ADDENDUM	REVISION	PLOT DATE	DESCRIPTION	BY
△	1	10-15-20	REMOVED "COURSE"	NHP

PROJECT NAME: WHITINGHAM
PROJECT NUMBER: STP FPAV(34)

FILE NAME: I9V038 Whitingham.dgn PLOT DATE: 09-OCT-2020
PROJECT LEADER: B. KIPP DRAWN BY: N. PAPPAS
DESIGNED BY: N. PAPPAS CHECKED BY: B. KIPP
PROJECT NOTES SHEET SHEET 4 OF 21

PROJECT NAME: WHITINGHAM
 PROJECT NUMBER: STP FPAV(34)
 FILE NAME: I9V038 Whitingham.dgn
 PROJECT LEADER: B. KIPP
 DESIGNED BY: N. PAPPAS
 TYPICAL SHEET 1

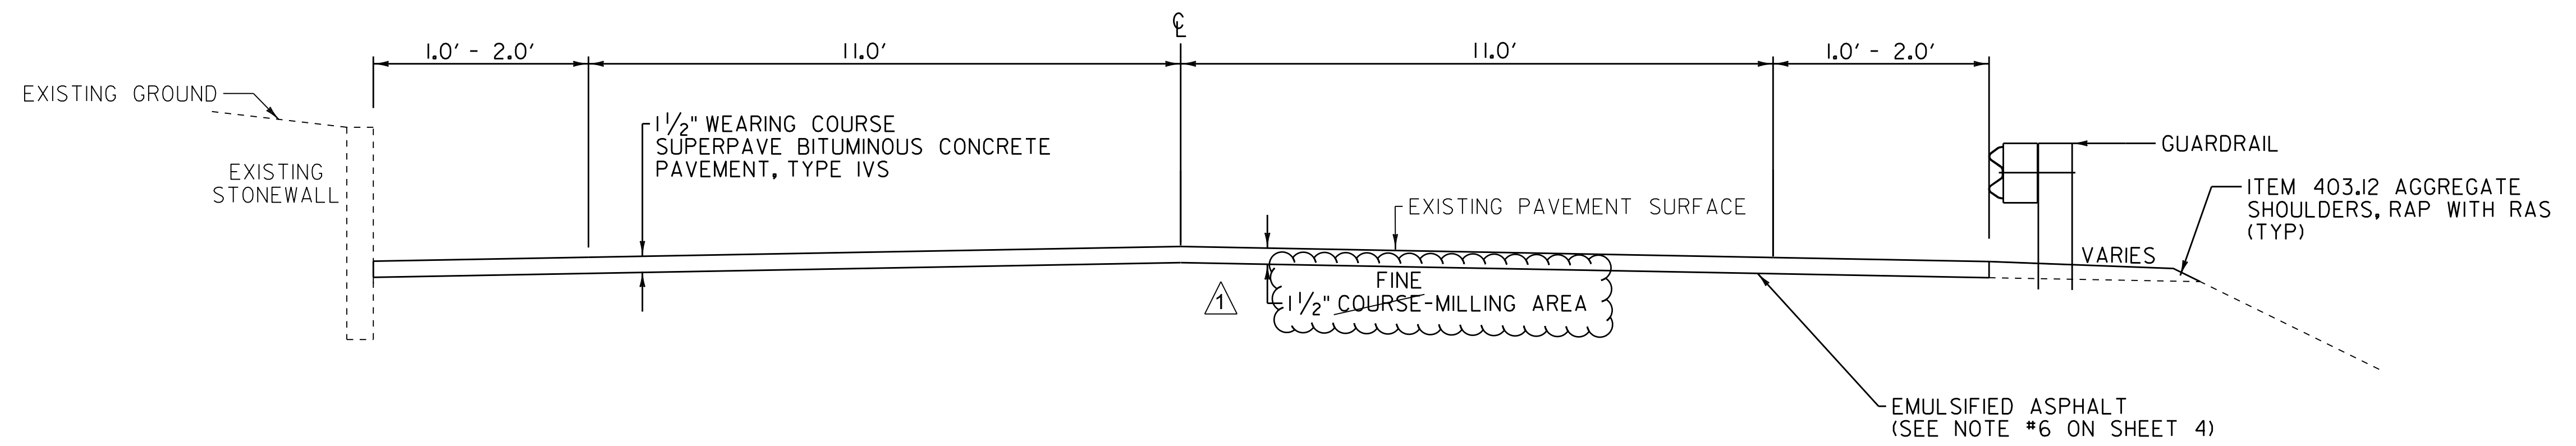
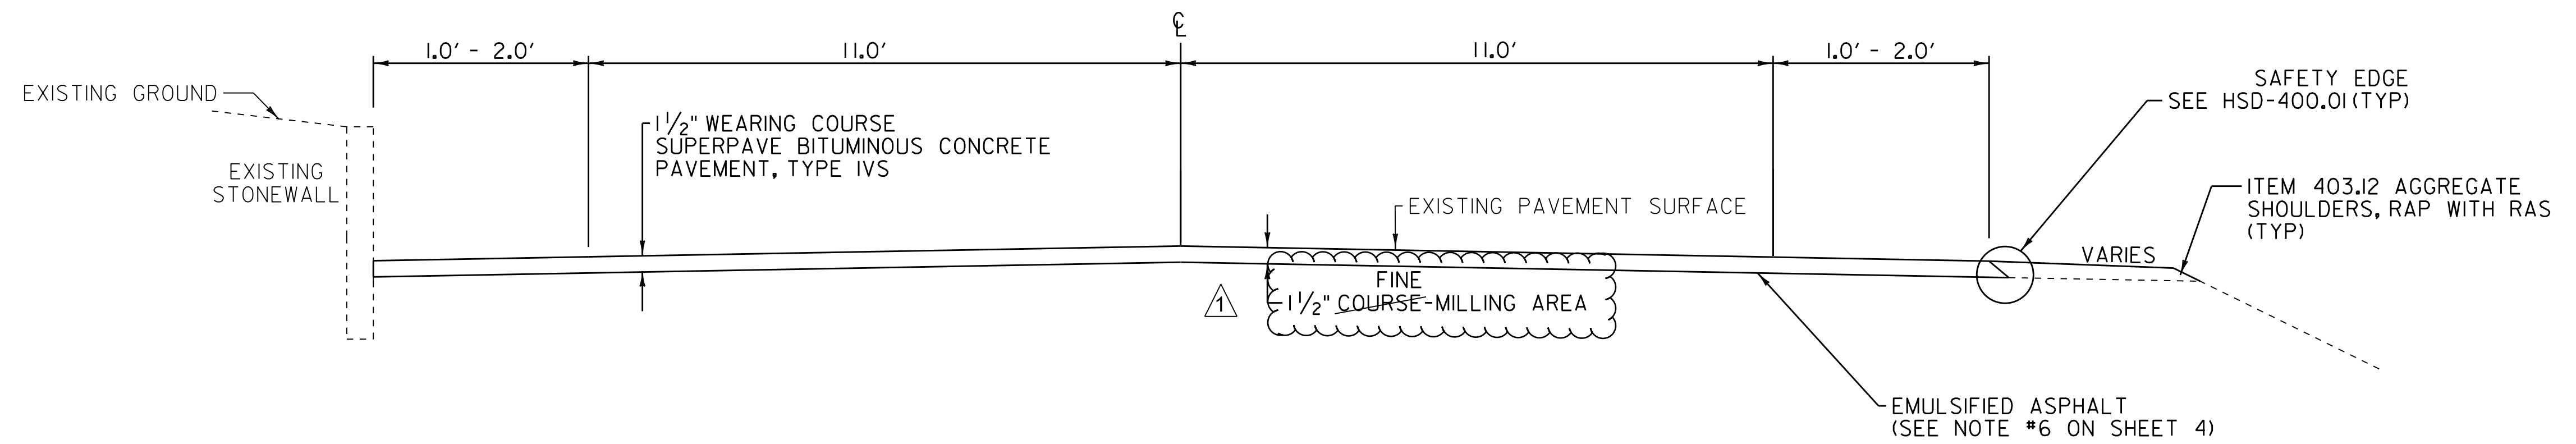
ADDENDUM	REVISION	PLOT DATE	DESCRIPTION	BY
1	1	10-15-20	REMOVED "COURSE" & REPLACED WITH "FINE"	NHP

PROJECT NAME: WHITINGHAM
 PROJECT NUMBER: STP FPAV(34)
 FILE NAME: I9V038 Whitingham.dgn
 PROJECT LEADER: B. KIPP
 DESIGNED BY: N. PAPPAS
 TYPICAL SHEET 2

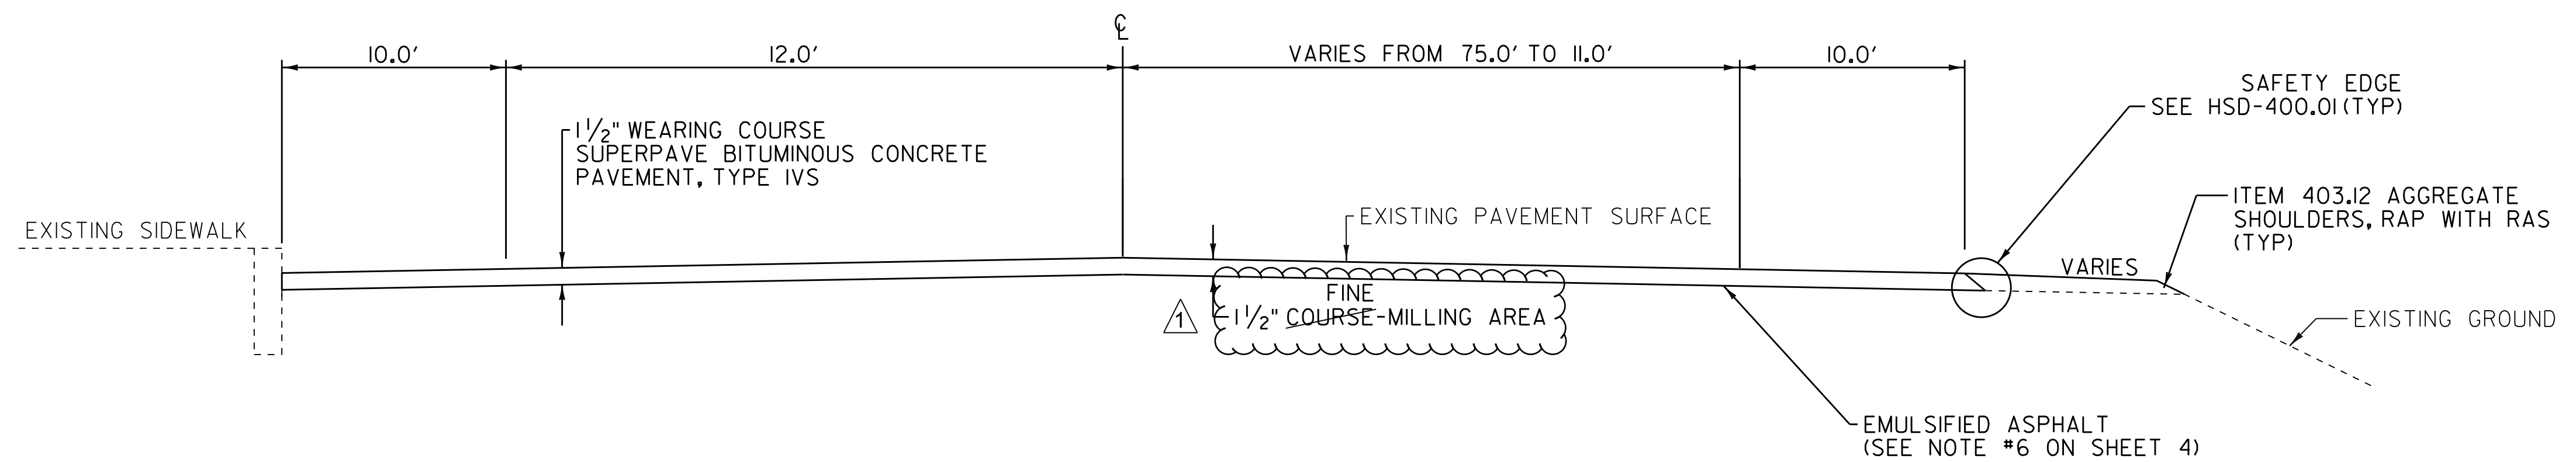
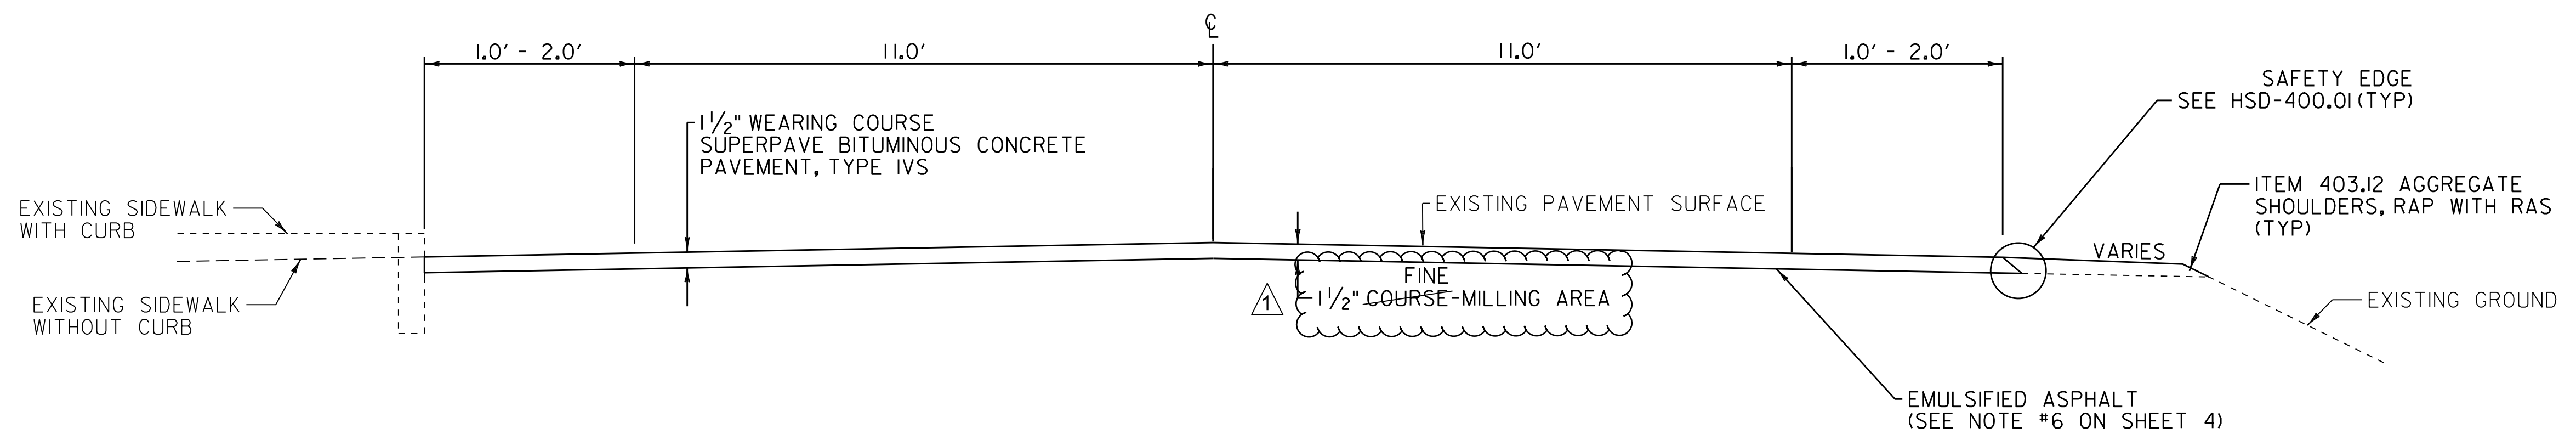
ADDENDUM	REVISION	PLOT DATE	DESCRIPTION	BY
1	1	10-15-20	REMOVED "COURSE" & REPLACED WITH "FINE"	NHP

MAINLINE BEGIN AND END APPROACH DETAIL

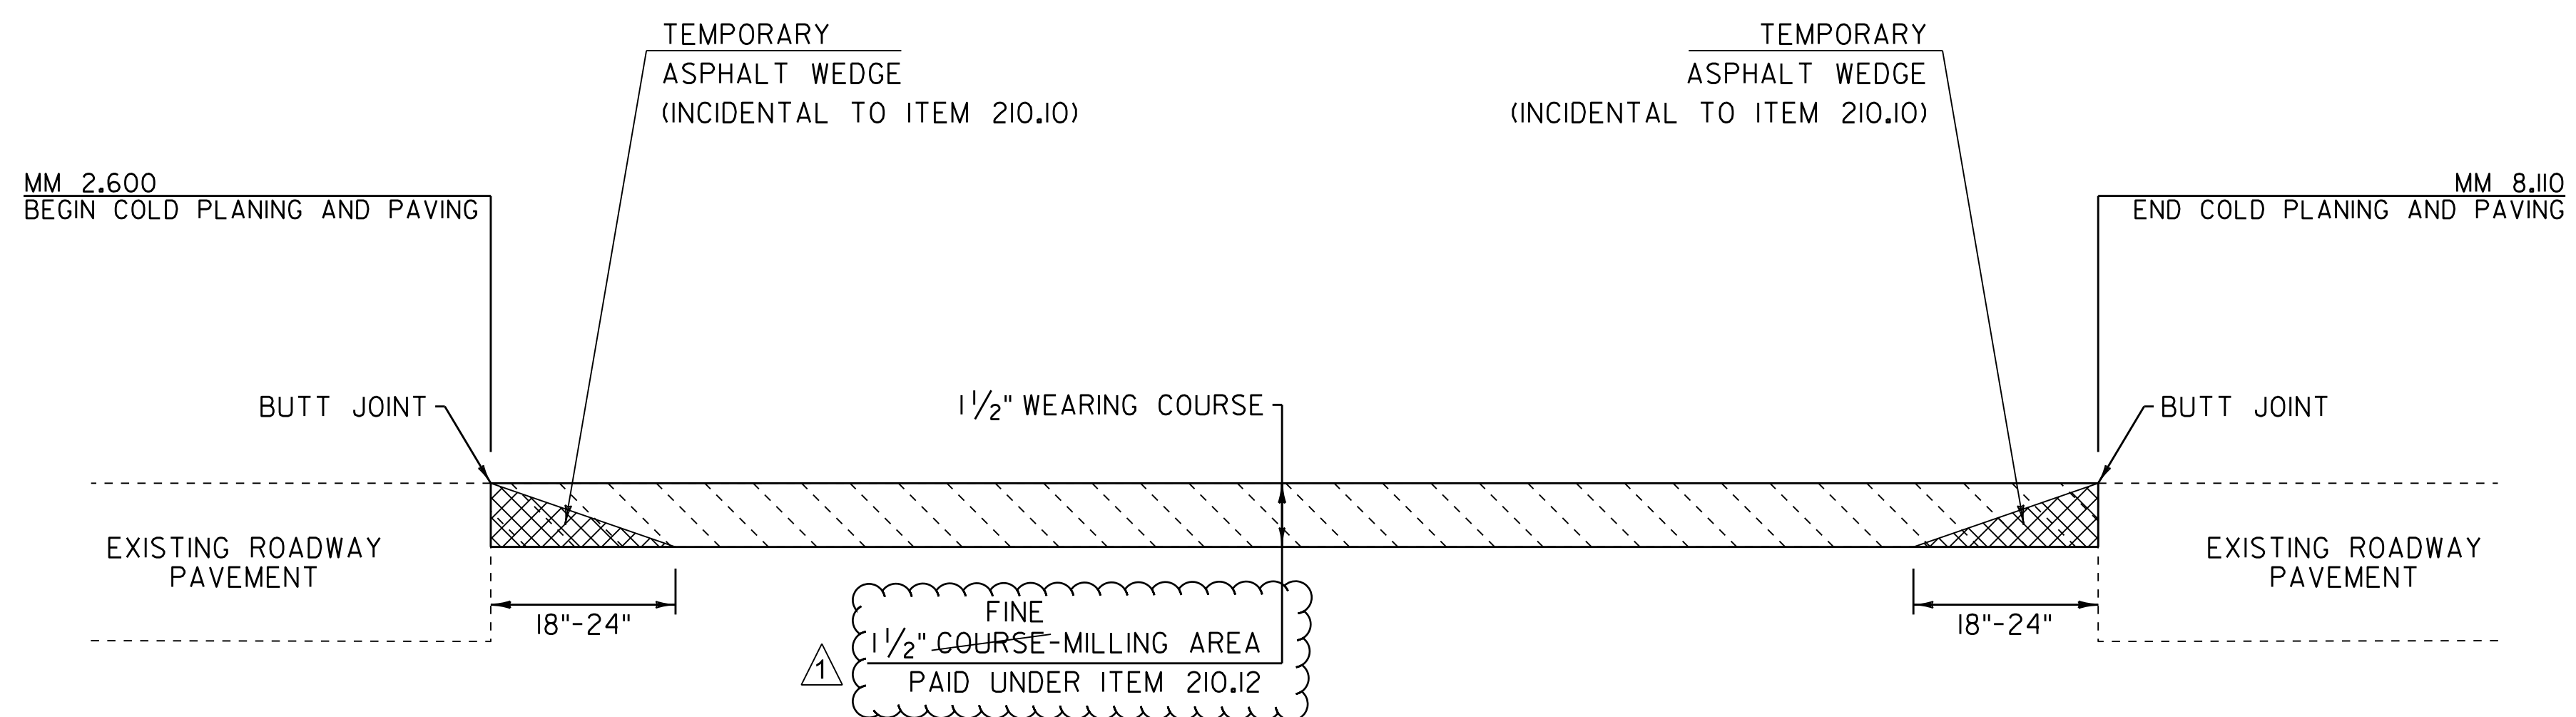
ADDENDUM	REVISION	PLOT DATE	DESCRIPTION	BY
1	1	10-15-20	REMOVED "COURSE" & "210.10" REPLACED WITH "FINE" & "210.12"	NHP

PROJECT NAME:	WHITINGHAM
PROJECT NUMBER:	STP FPAV(34)
FILE NAME: I9V038 Whitingham.dgn	PLOT DATE: 09-OCT-2020
PROJECT LEADER: B. KIPP	DRAWN BY: N. PAPPAS
DESIGNED BY: N. PAPPAS	CHECKED BY: B. KIPP
PLAN SHEET	SHEET 17 OF 21

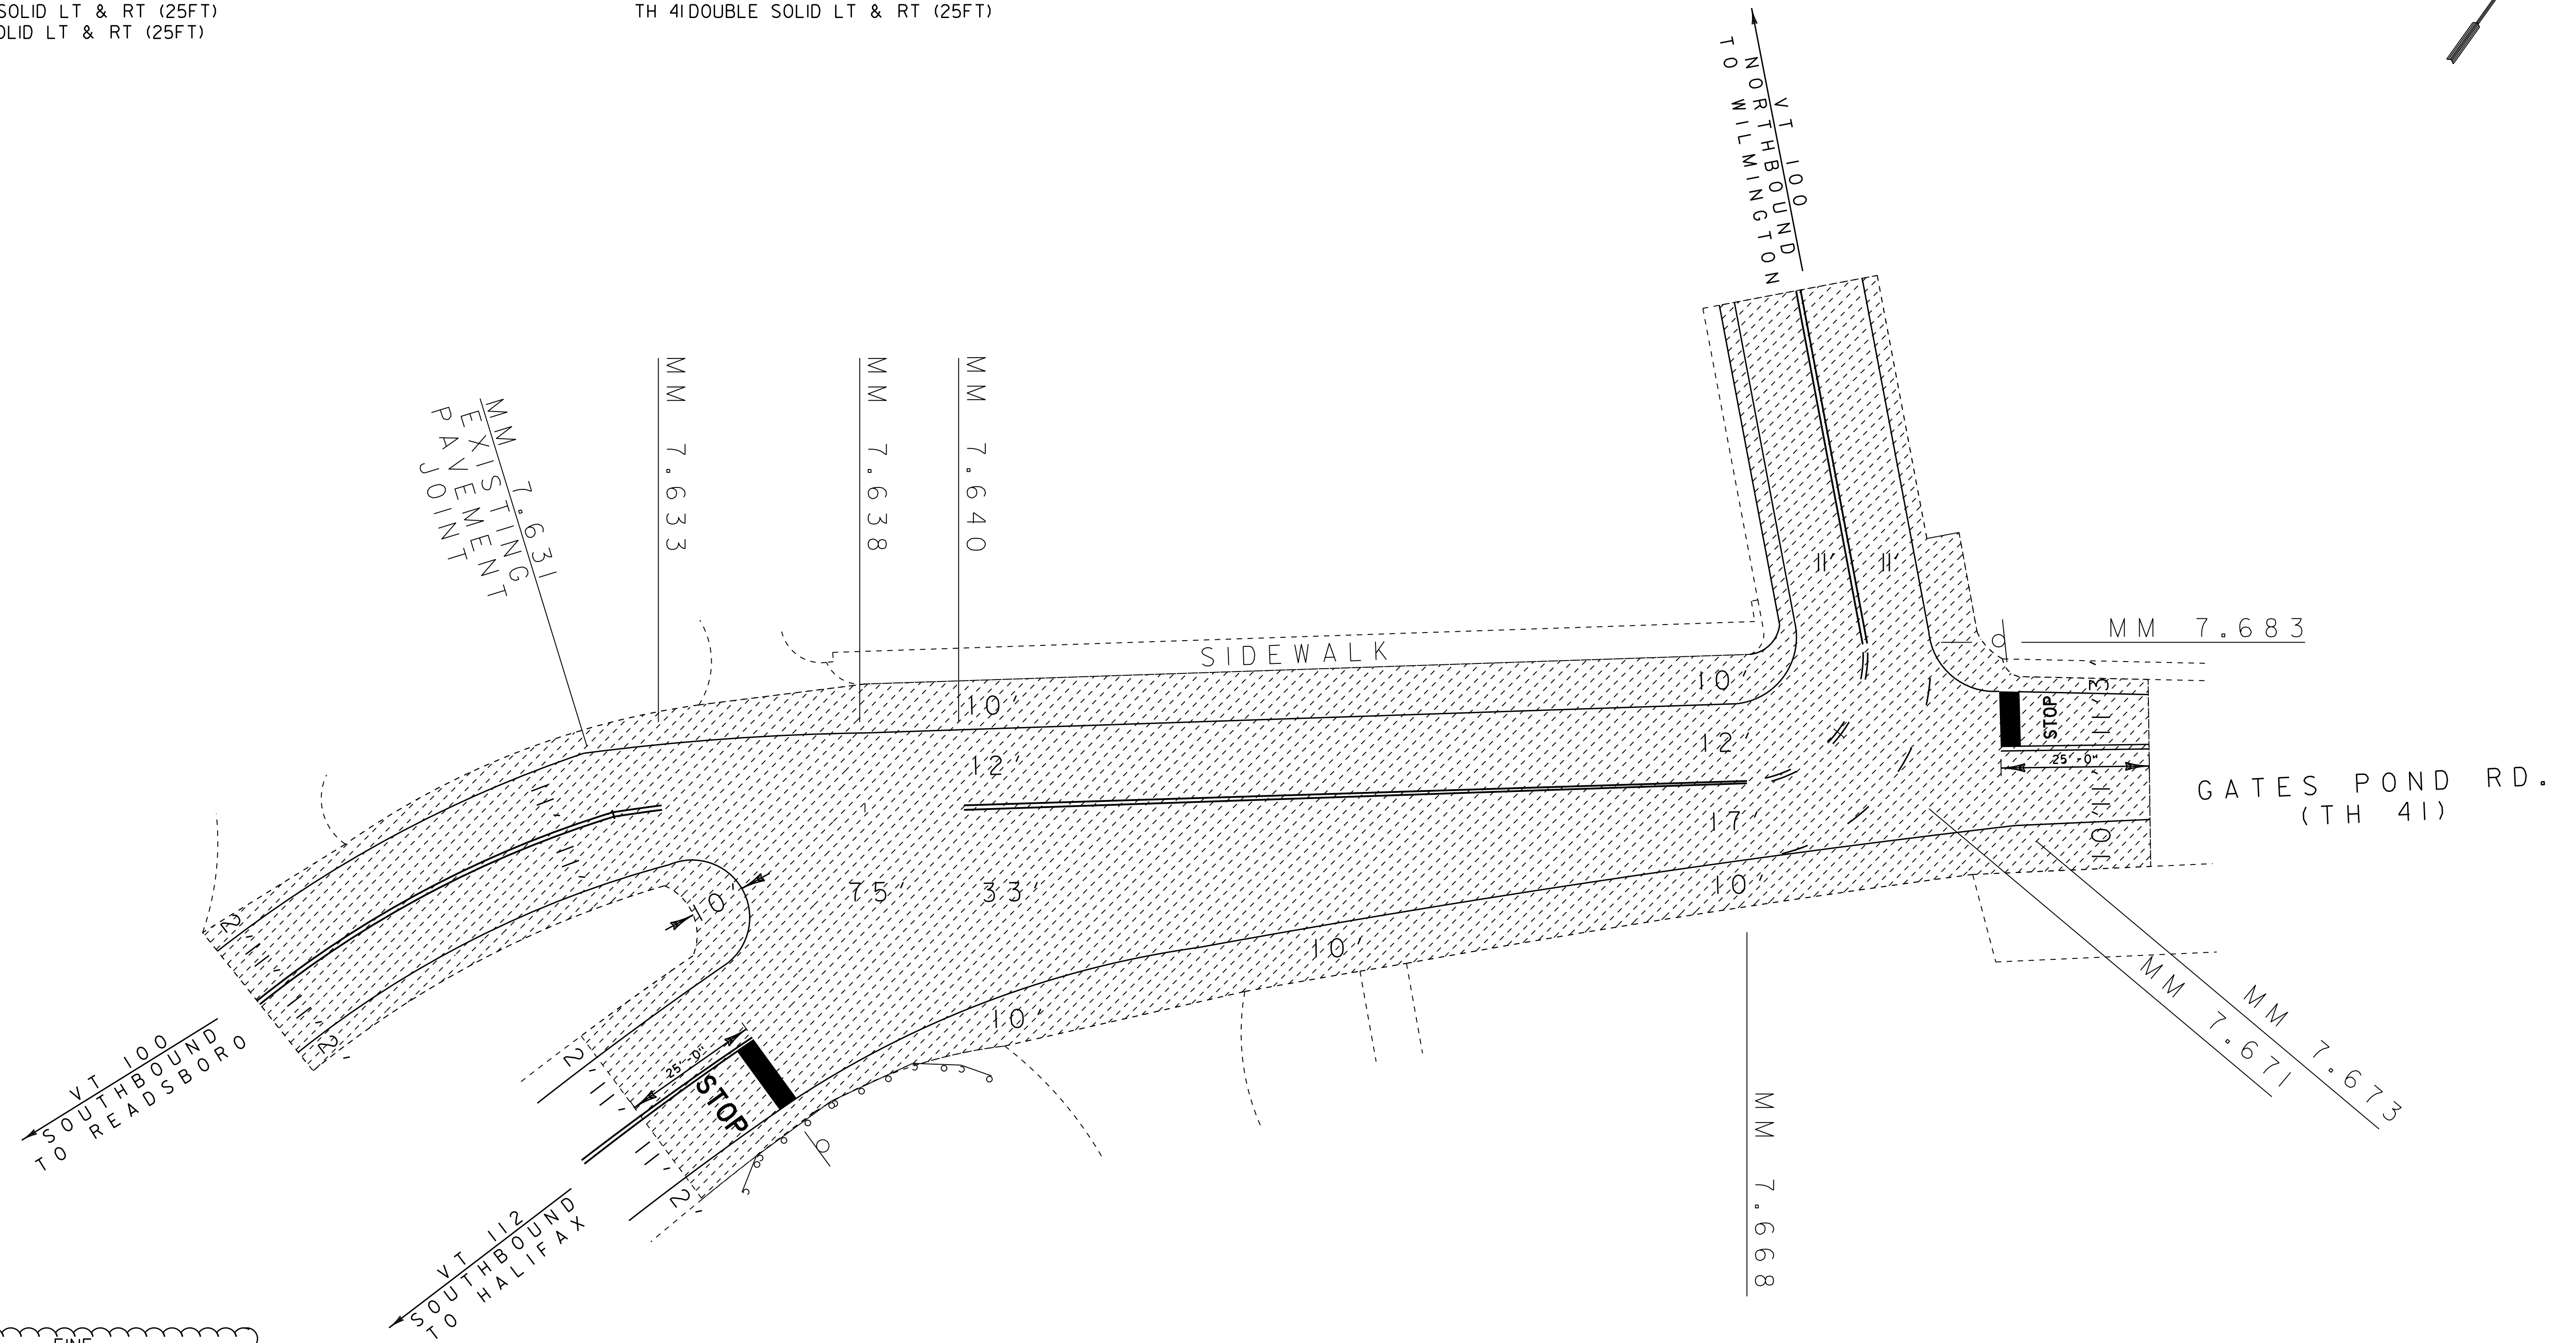
ADDENDUM	REVISION	PLOT DATE	DESCRIPTION	BY
△	1	10-15-20	REMOVED "COURSE"	NHP
